Product Change Notification / LIAL-19GWR786

CCB 4846 Final Notice: Qualification of ATP7 as an additional assembly site for selected ATSAMC20xx, ATSAMC21xx, ATSAMD20xx, ATSAMD21xx and ATSAML21xx device families available in 64L VQFN (9x9x1mm) package.

CCB 4846
Pre and Post Change Summary
PCN#: LIAL-19GWRY786

ASE

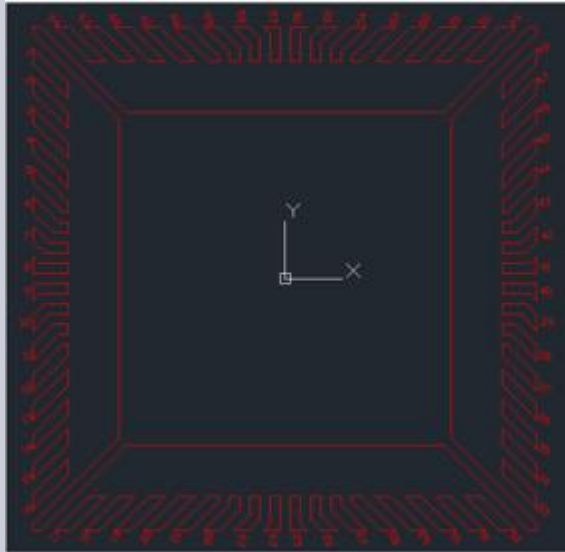
Lead frame	Paddle size	193 x 193 mils
	DAP Surface Prep	Ring Plating

ATP7

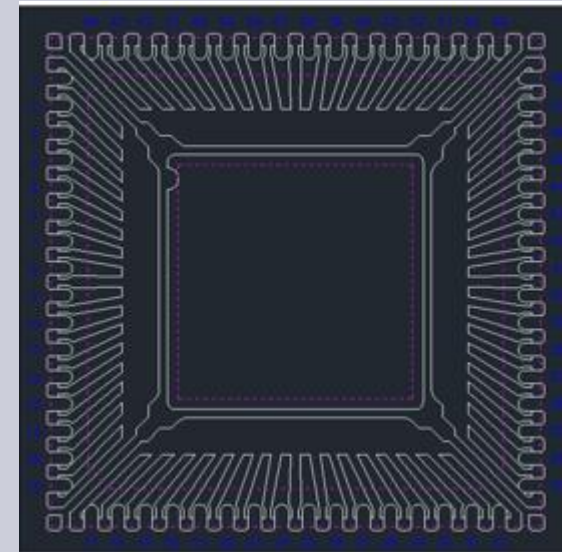
Lead frame	Paddle size	197 x 197 mils
	DAP Surface Prep	Double Ring Plating
